2019 CIP Compliance Seminar

This document provides SERC staff responses to questions asked by entities. The information provided herein is intended, on its date of posting, to provide guidance to the industry. Actions based on this information shall have no standing for the purpose of contesting or mitigating any findings of noncompliance by SERC. Compliance depends on a number of factors including the precise language of the Standard, the specific facts and circumstances, and the quality of evidence. Compliance will continue to be determined based on language in the NERC Reliability Standards as they may be amended from time to time.

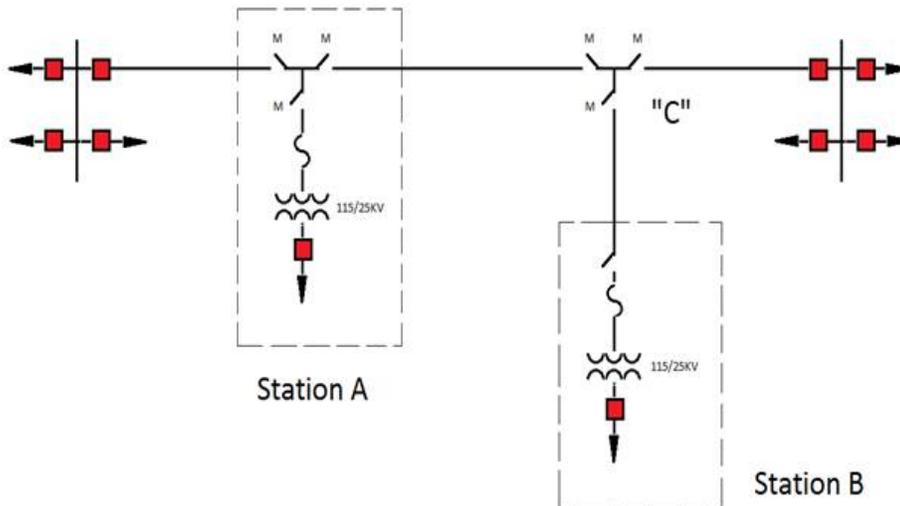
For the Diagram below:

The switching stations at either end of the line clearly must be considered, but what about Station A? Station B? What about switch “C”?

The response provided by SERC seems to be based only upon whether or not SCADA is used to operate the network switches at Station A and Location C and if they are controlled by SCADA then SERC concluded they are within CIP scope.

- 1) Is it SERC's position that every BES asset must be an impact-rated facility? If so, please explain how that is consistent with the NERC approved guidance.

- 2) Should a "distribution station" be considered to fall within the category of "Transmission station and substation" simply because motor operated switches are within the station fence (i.e., Station A), if asked for a list of Transmission stations as the guidance allows for this?

- 3) Is a Switch Junction to be considered to fall within the category of "Transmission station and substation" (Location C)? If so, on what basis?

- 4) Is there any basis for removing any of the network switches from CIP scope?

Assuming that the horizontal line is a Low Impact BES Element and the four “M” breakers on the horizontal line are BES Elements, Station A will be Low Impact, but the vertical breaker leading down and the items below it are a radial distribution Element and, thus, out of scope for CIP.

Station B is radial distribution only; so it is out of scope for CIP

Depending on the configuration details of “C”, it may be a BES Element. SERC requires additional information to determine the correct assessment.

RESPONSE: SERC's position is that Facilities are not impact rated, BES Cyber Systems are. Not every BES Facility will have supporting cyber assets which meet the definition of BES Cyber Assets, which would make such a Facility not "have" high, medium, or low impact BCS. A substation with completely electromechanical protection systems and no RTU or other cyber assets would not have high, medium, or low impact CSs.

RESPONSE: All BES Facilities at the asset location should be considered.

RESPONSE: If the "Switch Junction" is a location where groups of Transmission Facilities exist, then it should be considered applicable to Rii.

RESPONSE: If they qualify under a BES Exemption, or under the Applicability section, then yes.
